KA Design Limited

Client Summary report

Observations & Actions

Displacement of toilet block attached with Main Production Shed at west

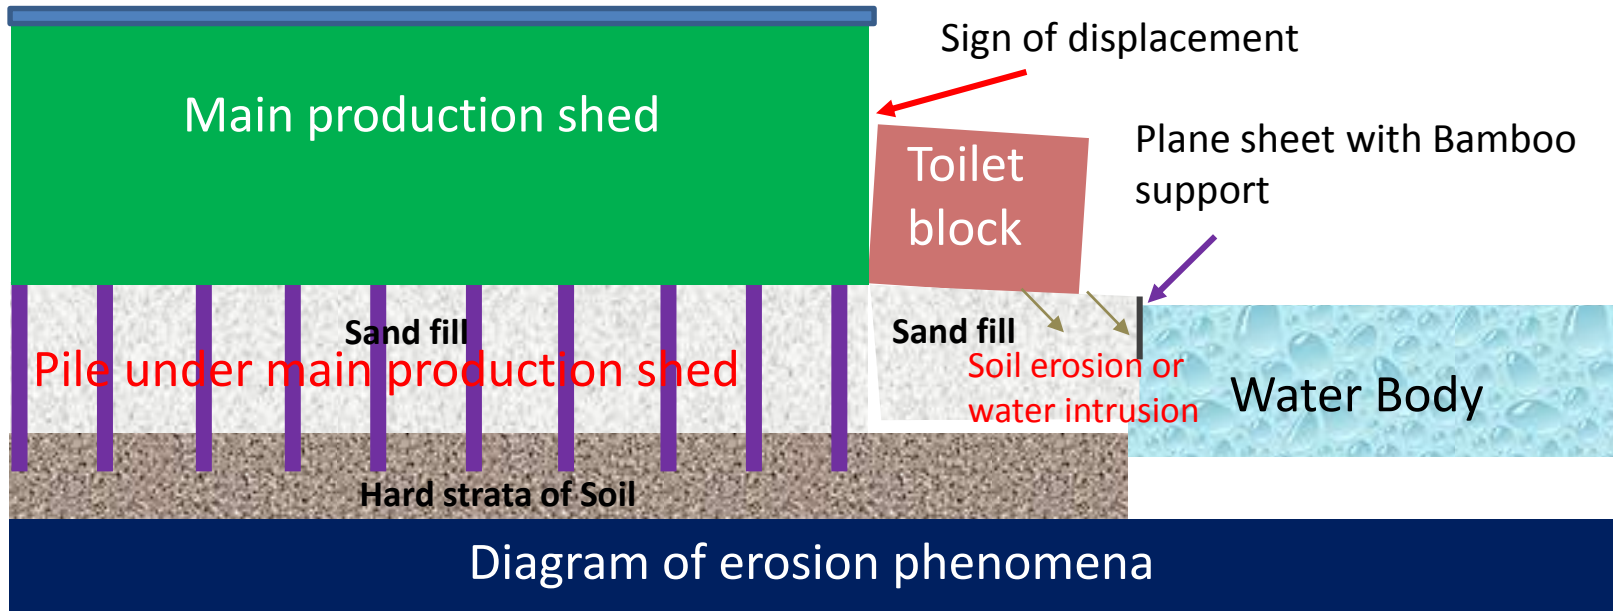
Toilet area settle down and displaced from its actual position

The factory was built in moorland by sand filling. The Factory buildings are surrounded by Water body. At west side it is too close, almost 6-7 feet away from toilet block shown in figure. The main production shed built with pile foundation but the toilet block has none. The protection of soil fringe is not sufficient so that soil erosion or water intrusion may occur. By this toilet block is continuously settling down and sign of displacement and continuous repair work was visible during inspection.

Apparently Non-engineered steel stair attached with north façade wall

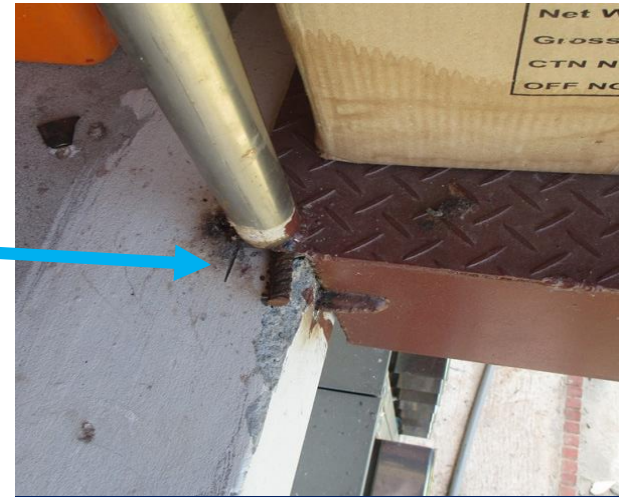
Non-engineered steel stair at north

Poorly connected with façade wall

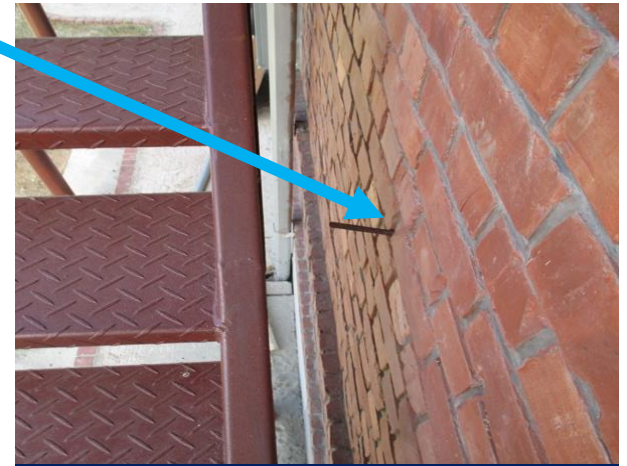
No connected with façade wall

Discrepancies between Structural drawings and site observations

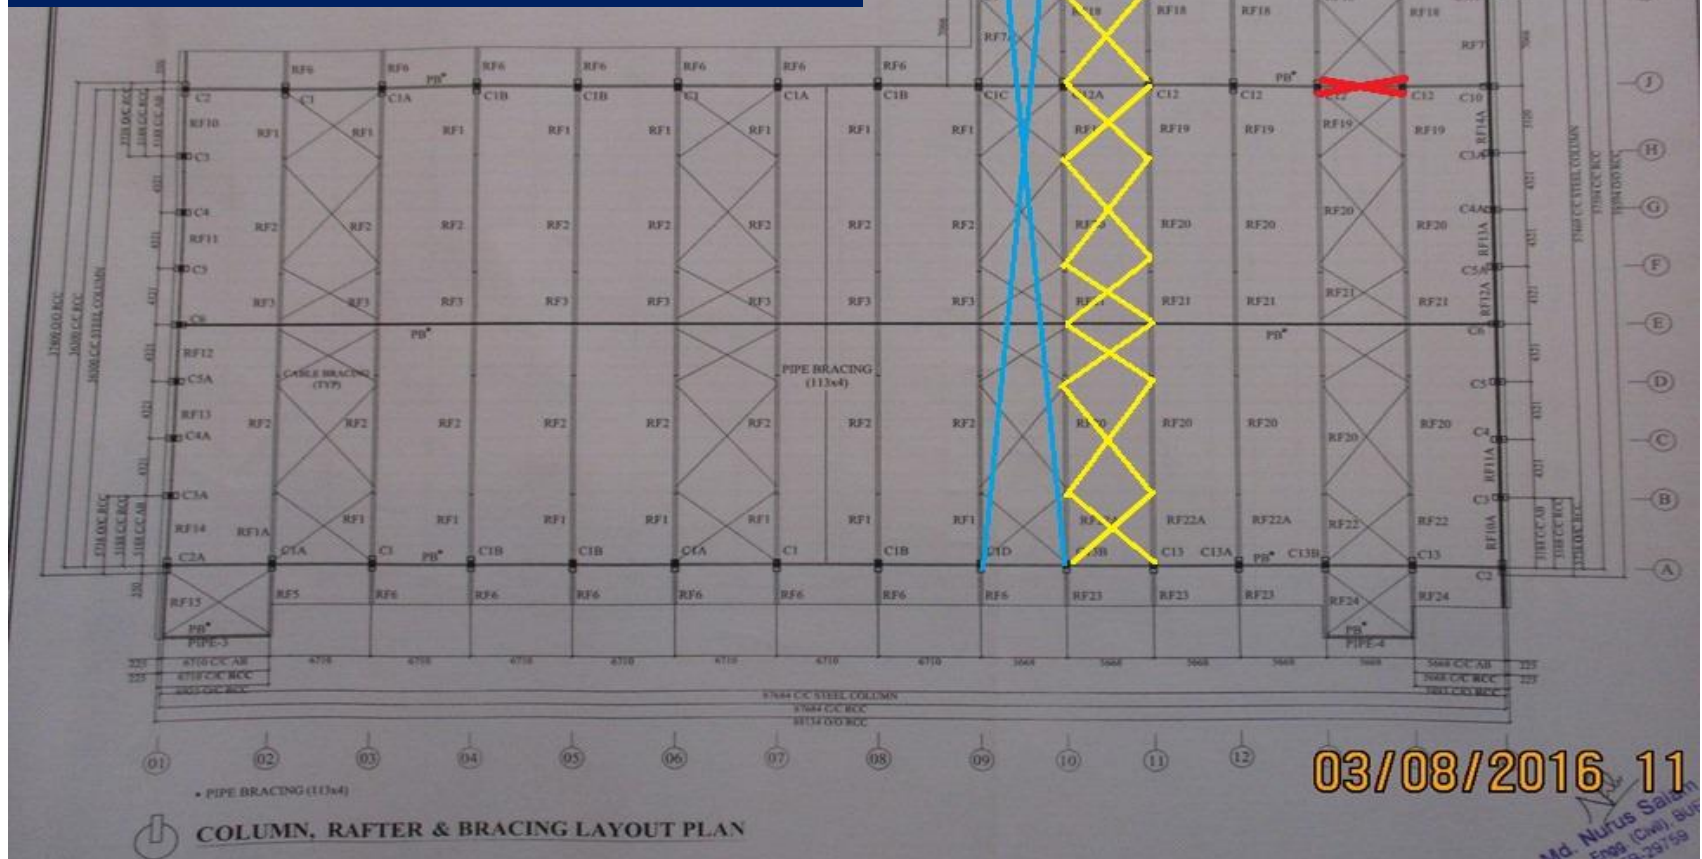
Bracings in between grid 9-10 are not installed according to drawing. Practically that bracing were found in between grid 10-11. One vertical bracing missing shown in red at drawing.

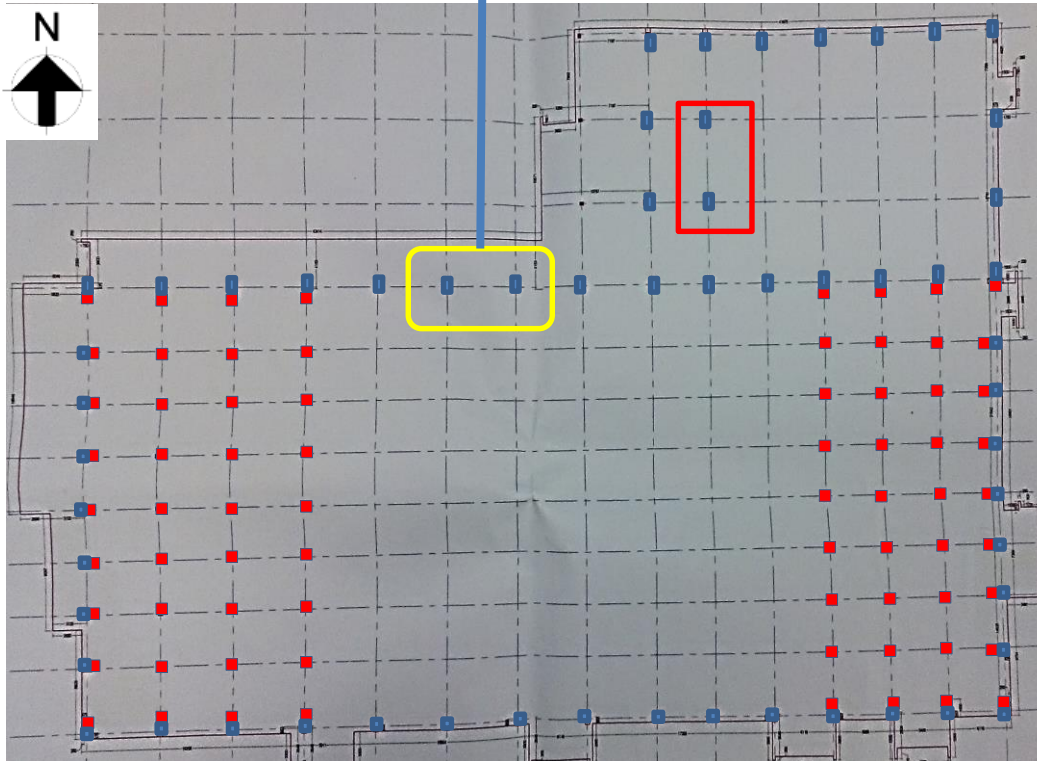
Column schedule for mezzanine floor didn't matched fully. C2, C3 & C4 columns are not exist upper Ground floor. Indicated columns in red box are not shown in column layout or foundation layout.

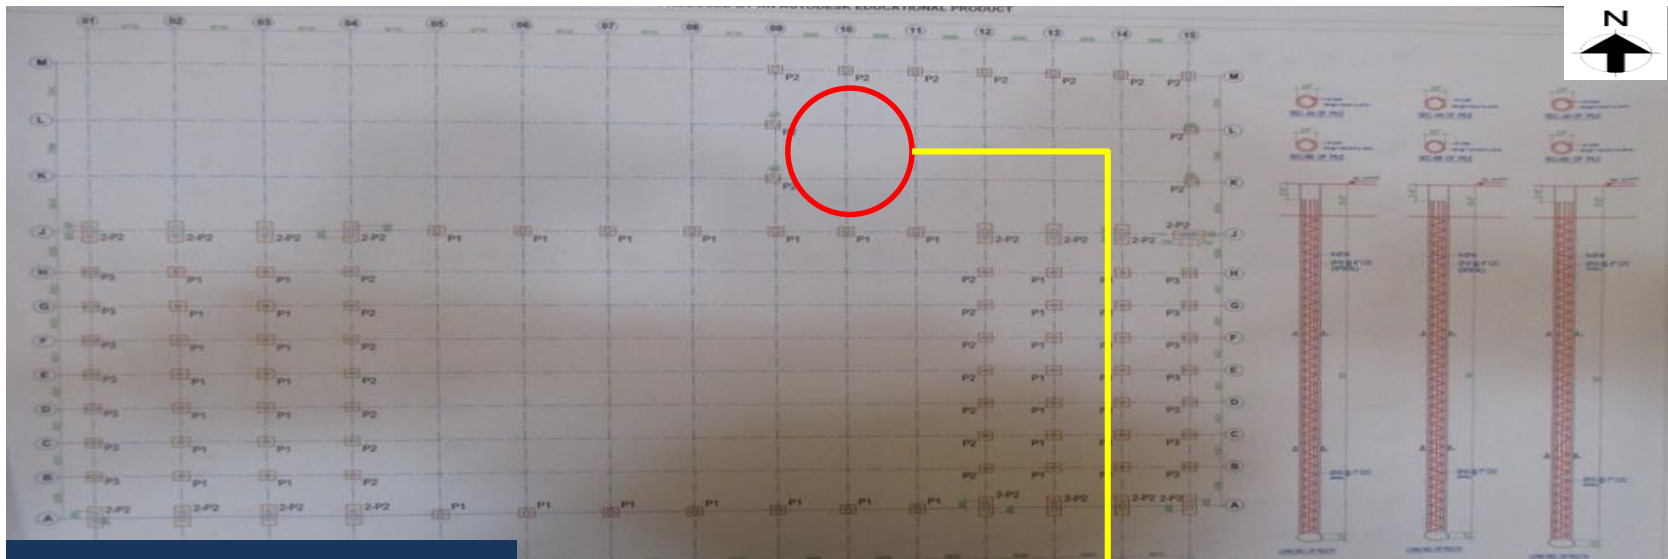
No foundation or support system is defined or mentioned for the extra columns which found in indicated portion.

Corrosion on base plate and column joint

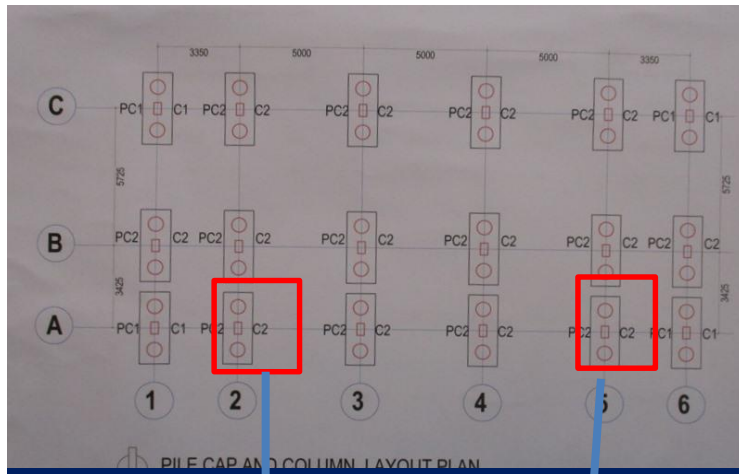
Corrosion observed on several base plate and column joint in main production shed

Structural drawing

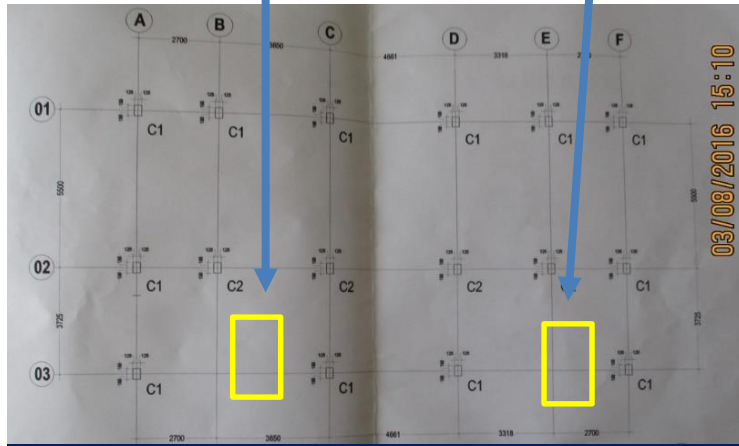
Column size measured 425X300 & 4x3 nos of rebar found

Provided column layout (Two columns are not shown)

Column Schedule is missing on structural drawing. Provided column layout & schedule didn't match with as built condition. Column size & number of rebar didn't match.

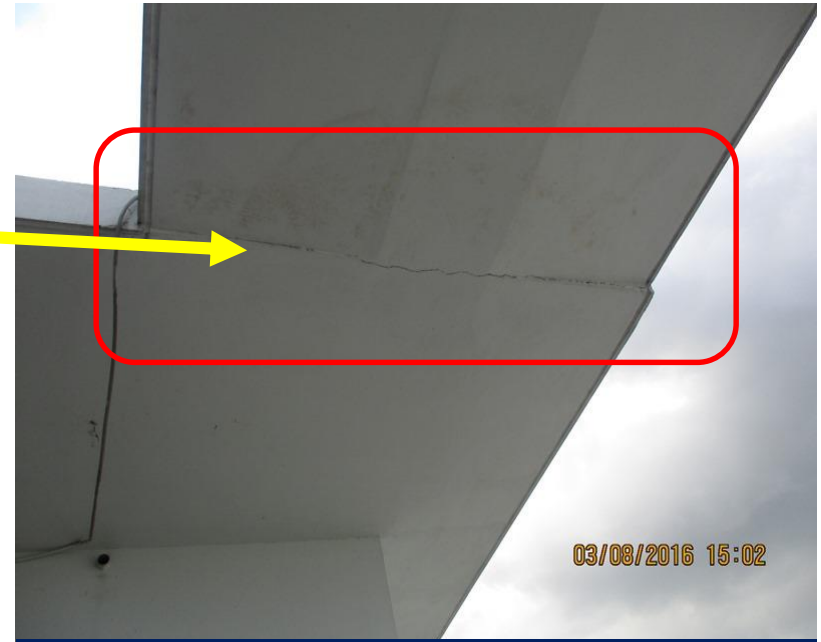
RC slab at roof and an expansion joint found at top of Dining Building. No detail information was found in structural drawing.

Cracks on ground floor slab and Brick walls due to soil settlement

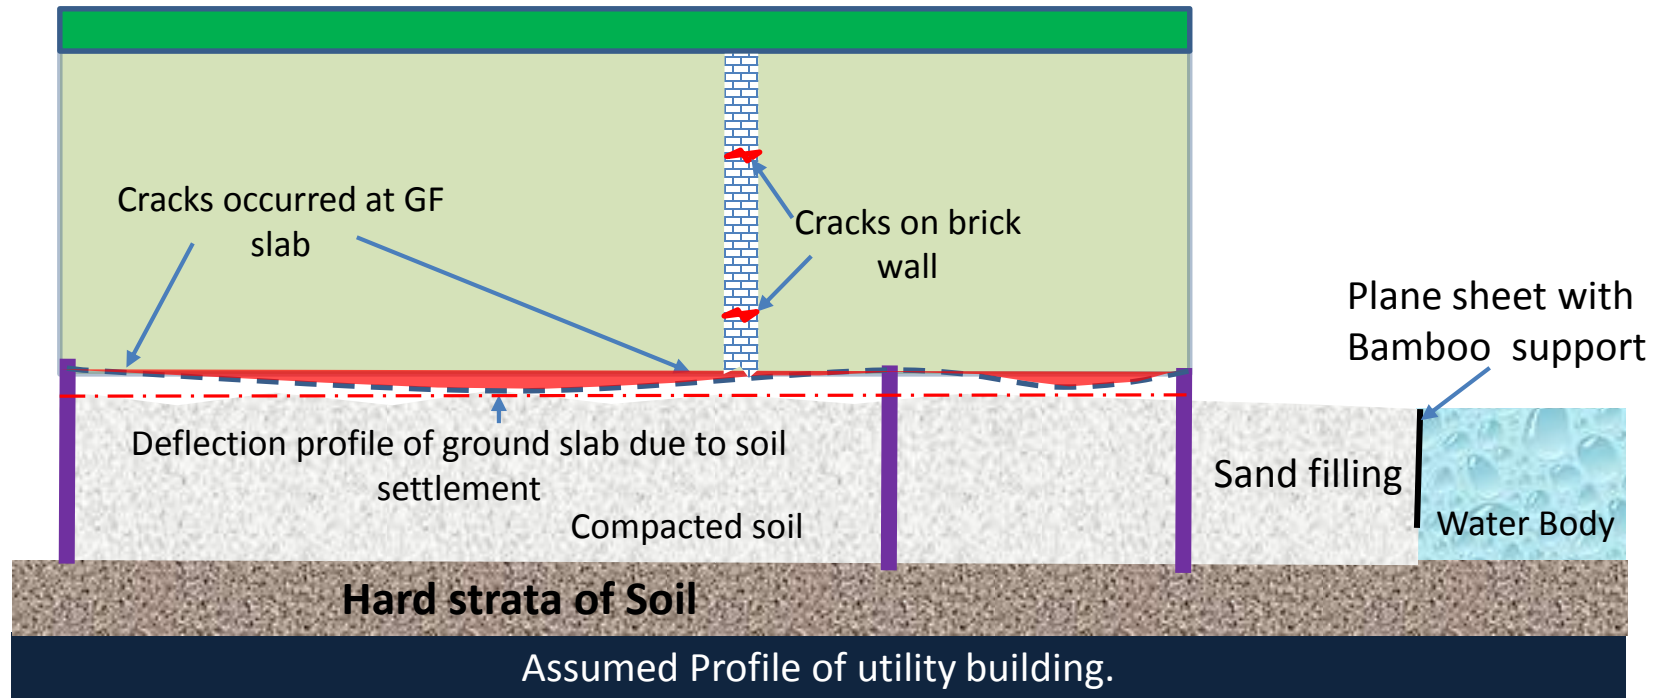
Ground floor has settled down and visible cracks observed on floor and partition wall

The Utility Building was built with pile foundation. The gap between two piles are almost 9m. There is no clear information about GF slab in structural drawing. GF floor may be made of brick soling. Though the building built in a moorland by sand filling and water body is very close to the building so that soil erosion or water intrusion can easily occur. By this soils are settling down and visible cracks on GF floor slab & brick wall were observed.

Unsupported Brick wall inside utility building

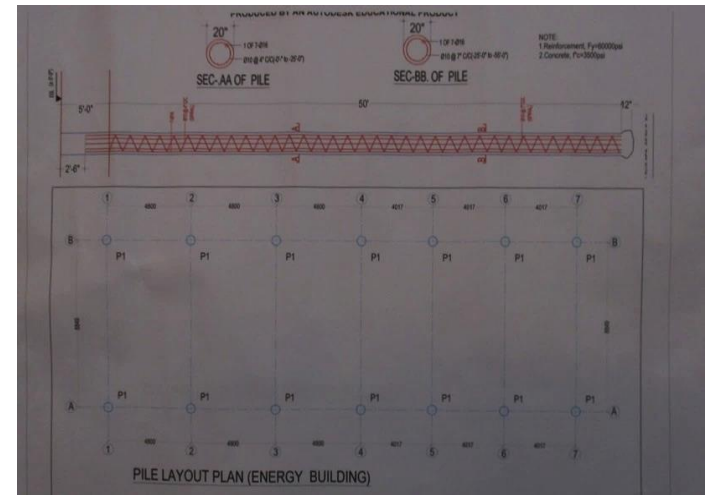
Unsupported 10" Brick wall observed

Loose bonding with column
